July 28, 2025

Franklin Conservation Commission
355 East Central Street
Franklin MA 02038

Re: Response to BETA Comments – Notice of Intent Peer Review
444 East Central Street, Franklin MA
(DEP File No. not yet issued)

Figure 2: Floodplain exhibit depicting FEMA's mapping and longitude/latitude point referenced in ORAD.

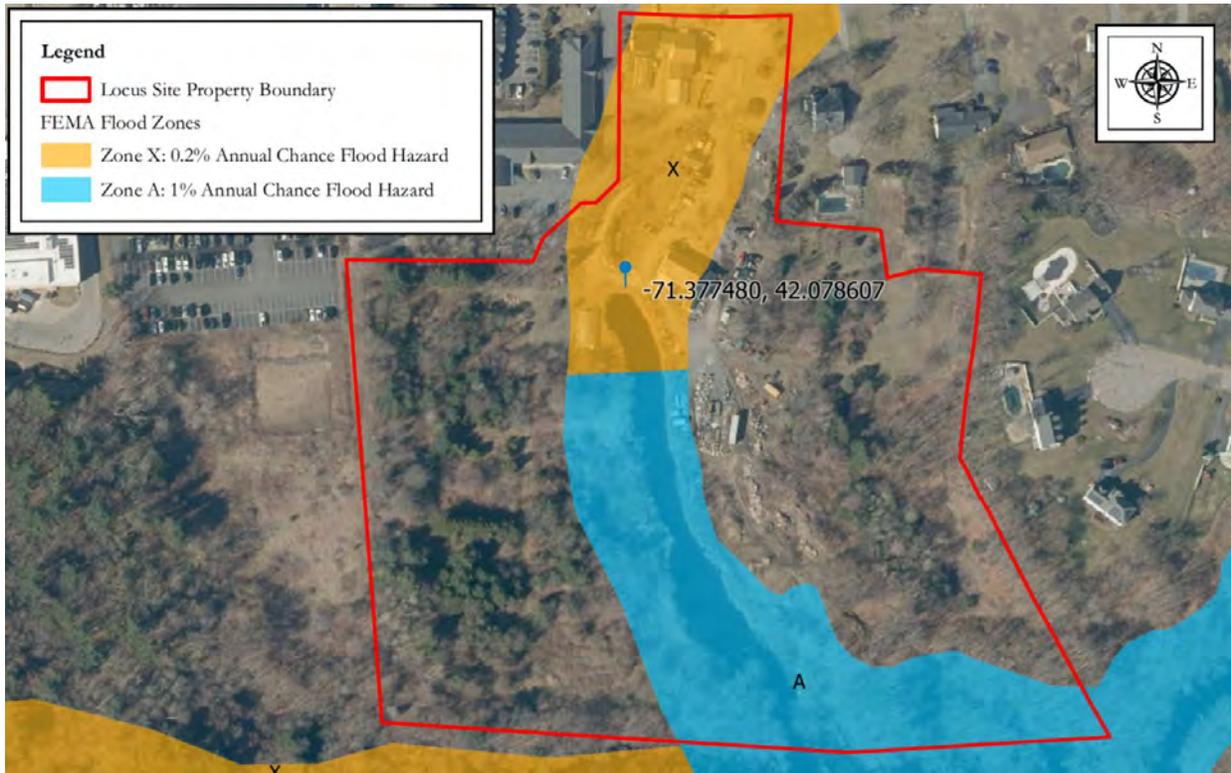
The Applicant should provide further information regarding how the extent of BLSF at the Site was determined, as the ORAD only approved portions of the BLSF at the Site. Given the number of stream crossings / hydraulic restrictions present at the Site, this evaluation should be prepared by a Professional Engineer with experience in hydraulics. The Commission may require more up to date engineering information than what is provided by FEMA per (310 CMR 10.57(2)(a)3., particularly given the presence of a Zone A with no published base flood elevation.

Figure 2 below illustrates two flood plains onsite, Zone X in the northerly area of the site and Zone A (100-year floodplain) in the south. Zone A constitutes BLSF, and its boundaries have

The approved ORAD confirmed the extent of BLSF as depicted on the approved site plans to the south of a point located at latitude/longitude -71.377480, 42.078607 (i.e. south of the southern culvert on site, as shown on the Exhibit). BLSF to the south of this point was confirmed at elevation 271'. Everything north of this point is already defined officially as a Zone X, per FEMA, which does not equate to BLSF.

A 100-year floodplain is not mapped by FEMA in this northern area in question, and no evidence exists indicating that it floods, so there is no presumption that BLSF should exist in the northern area; rather, there is more evidence supporting the contrary.

The Applicant has provided documentation and analysis supporting the delineation of BLSF as shown on project plans currently and as approved under the ORAD, which is consistent with FEMA's mapping and in compliance with WPA Regulations. No conflicting information has been produced, either in the ANRAD process or the NOI process.
